Comments on #FSP-26-0007 - Planning & Zoning: Final Subdivision Plat

Application Number: #FSP-26-0007
Application Type: Final Subdivision Plat
Date: June 29, 2026
Address: 1323 ROLESVILLE ROAD, ROLESVILLE

BROADMOOR - PHASE 2

MAJOR SUBDIVISION & RIGHT-OF-WAY DEDICATION PLAT
1323 ROLESVILLE ROAD, ROLESVILLE
WAKE COUNTY, NORTH CAROLINA
PREPARED FOR PULTE HOME COMPANY, LLC

Sheet 1 of 4

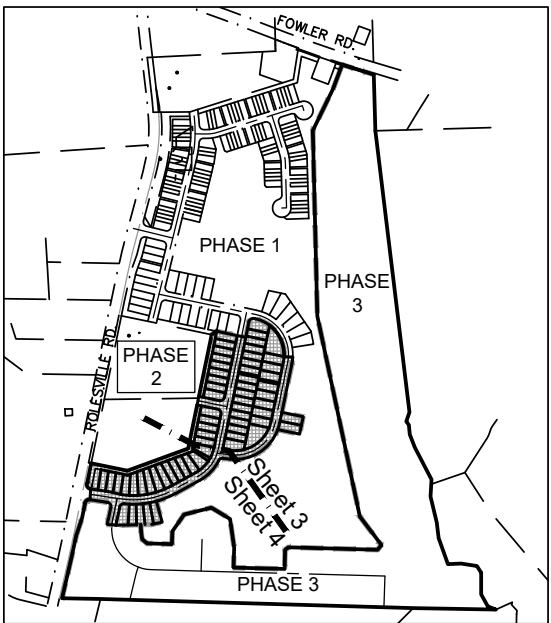
Pls add north arrow and scale

Submit to COR Energov portal. Include FSP-26-0007 in the Energov details for cross-reference purposes.

Add covenant BM & PG

pls add # of sfd and sfa lots

pls fill missing information

re: "Titan" - I believe this is meant to be "Titian" - QC and make changes to teh correct spelling everywhere on the plat.

Pls add lot width and setback table as shown on FSP coversheet example: <https://www.rolesvillenc.gov/sites/default/files/uploads/fsp-coversheet-example-2025.09.18.pdf>

Please take everything learned and worked out on the Phase 1 FSP, and apply it equally and accordingly on this - I would like to look at the next submittal with that lens, and hopefully nothing will be left to comment on. TY.

Pls add open space table

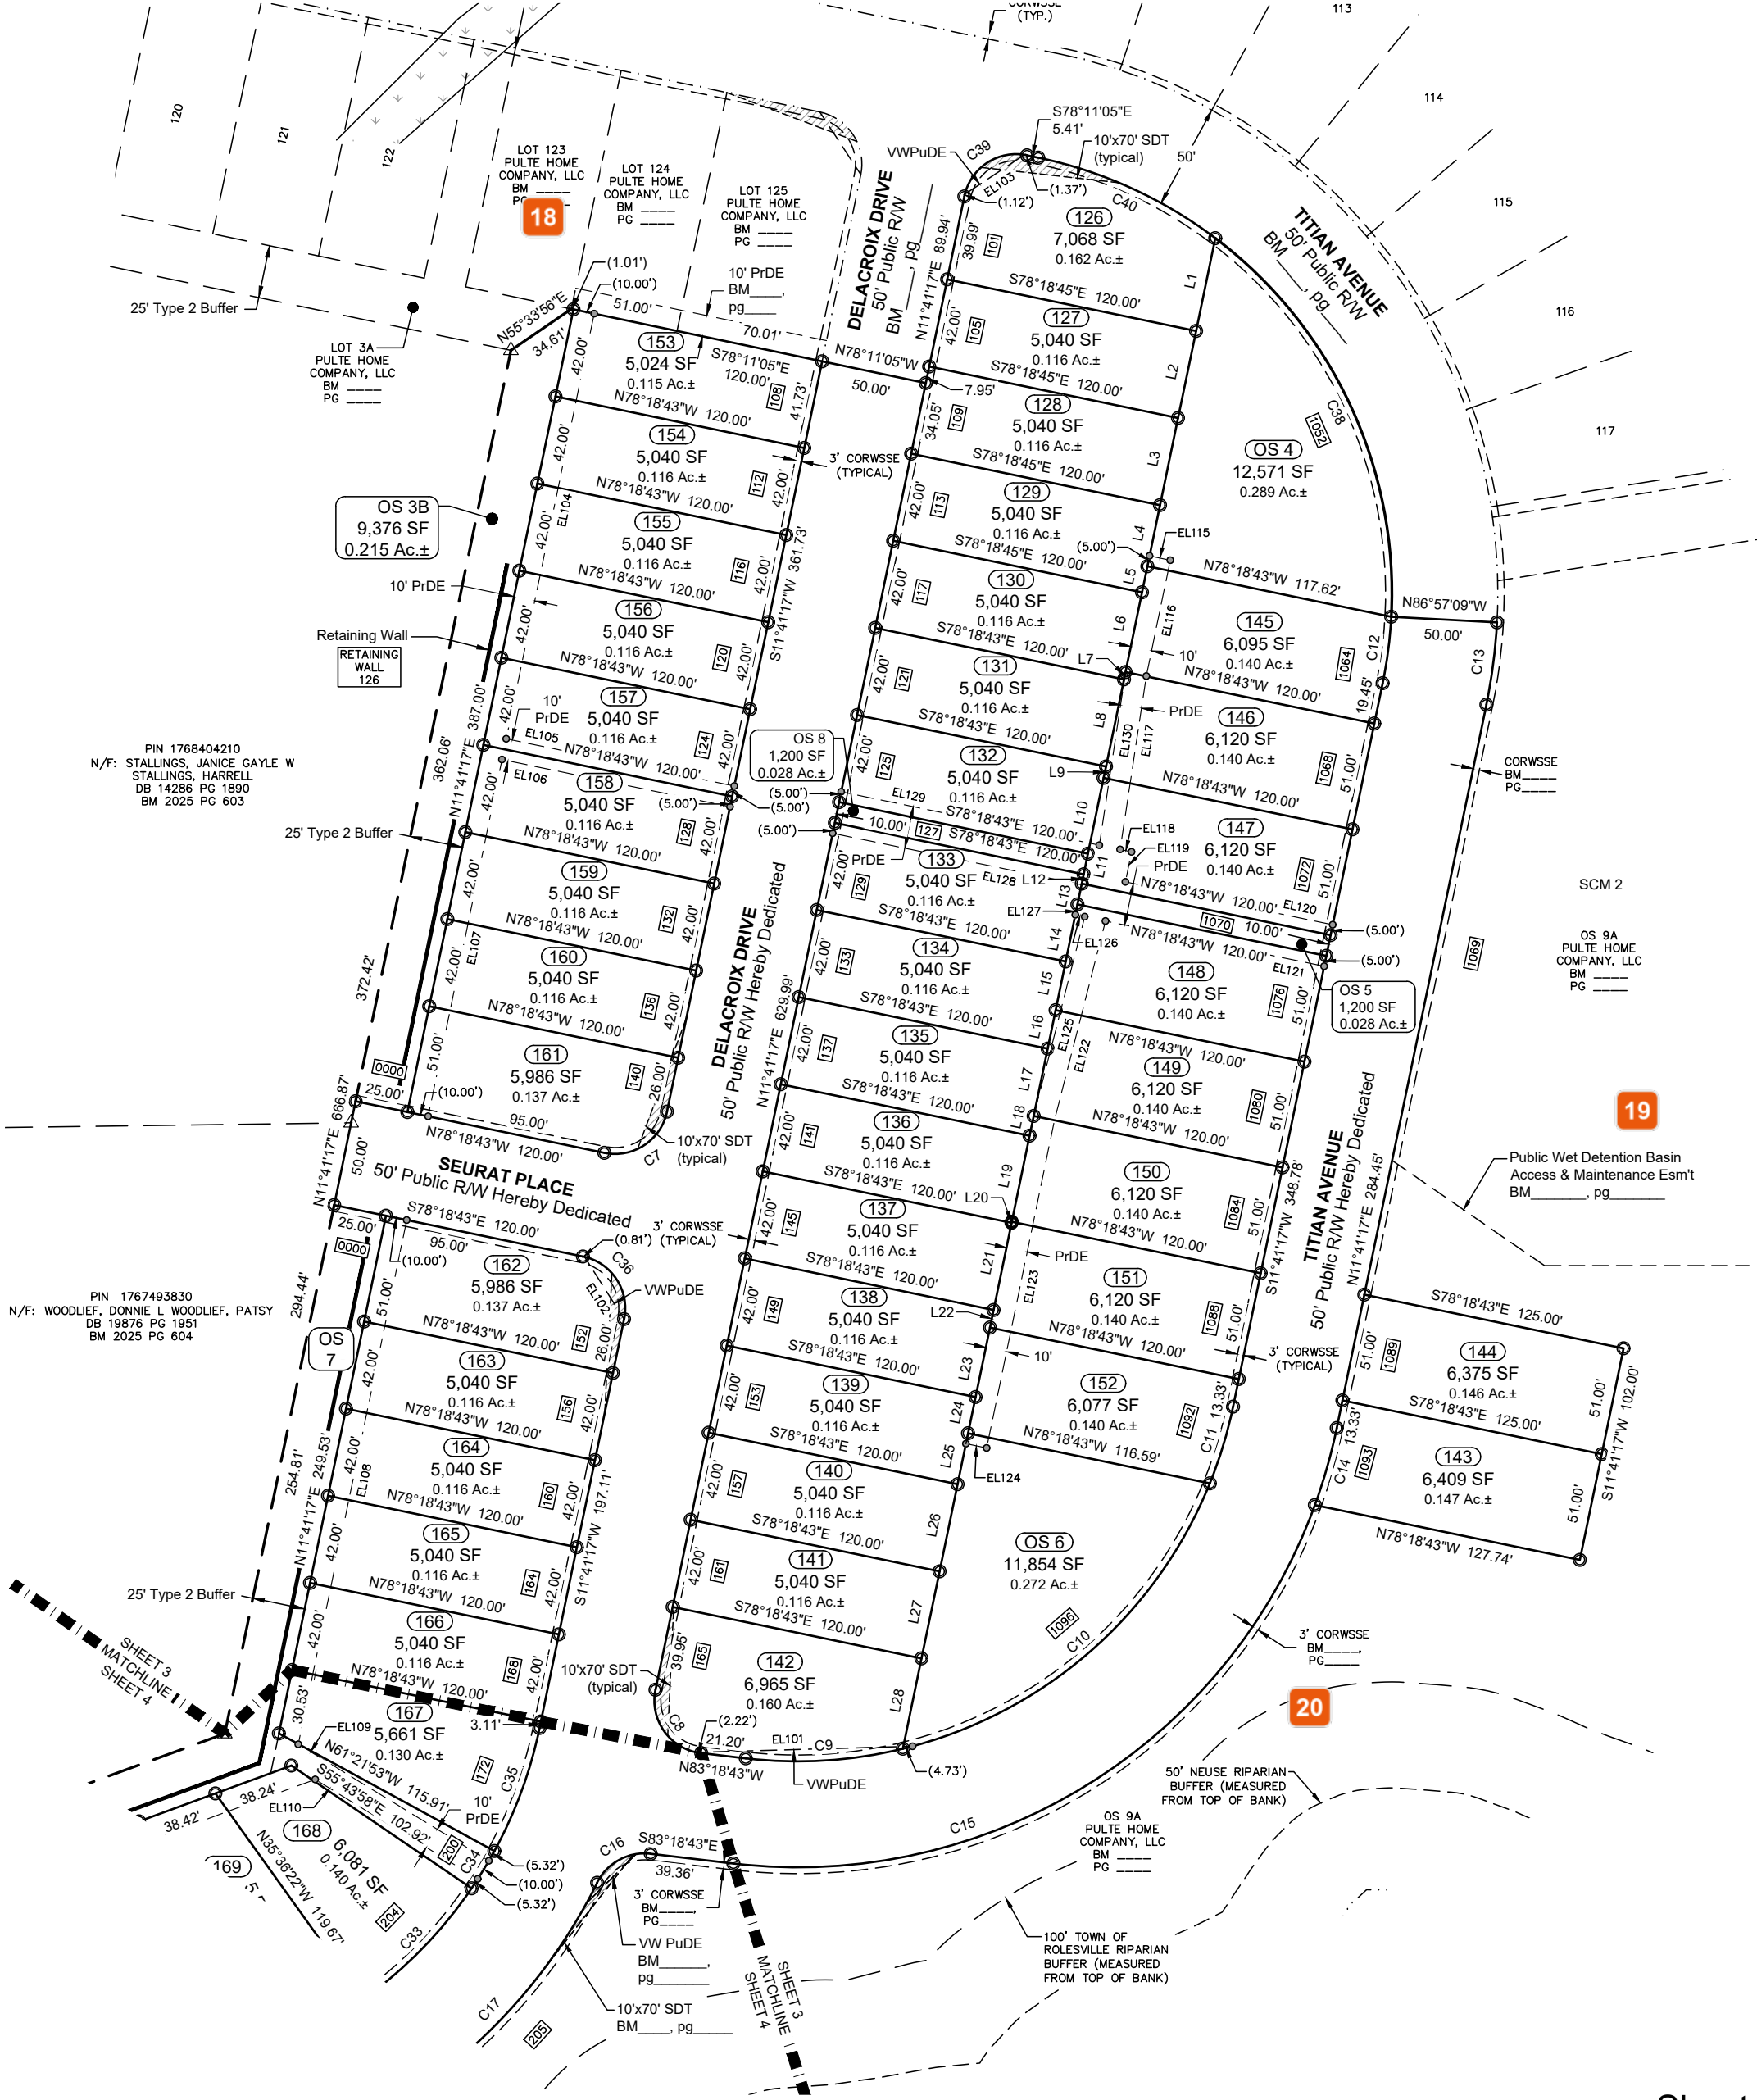
Pls add missing BM & PG

If these are proposed or to be dedicated, please remove BM & PG, then add to be dedicated.

Pls add BM & Pg

Sheet 4 of 4

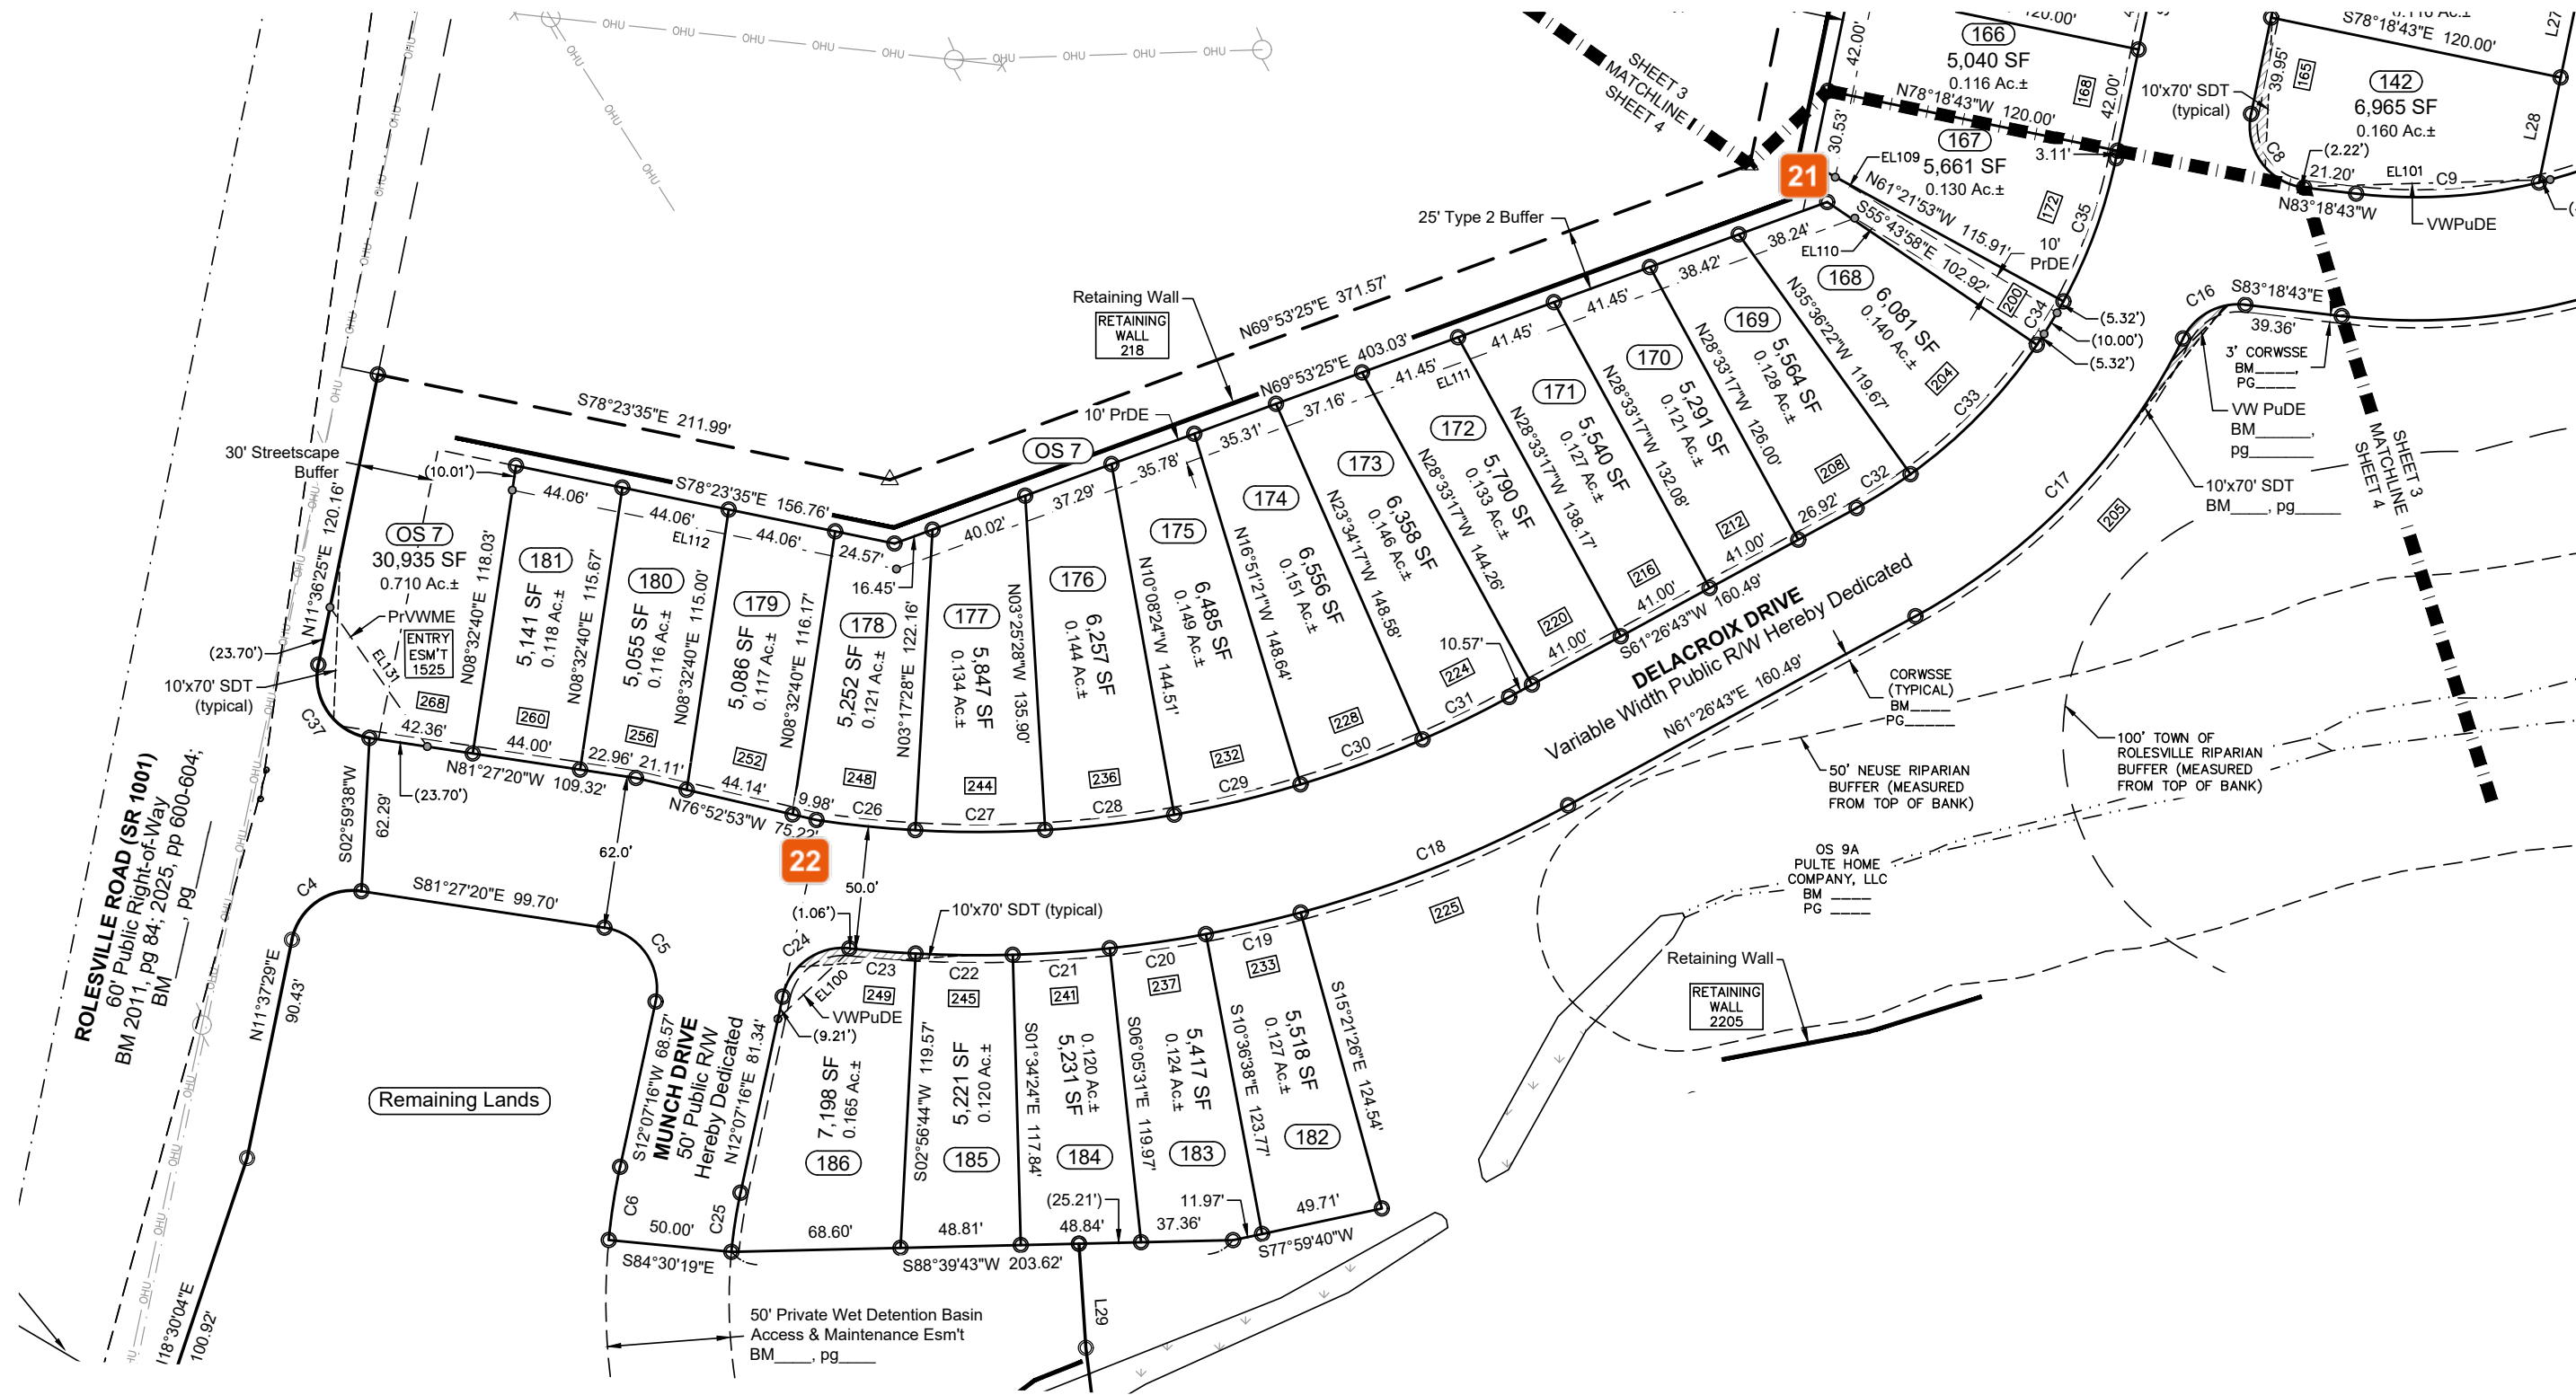
Please clarify what this dashed line is for.

Please clarify what this dashed line is for.
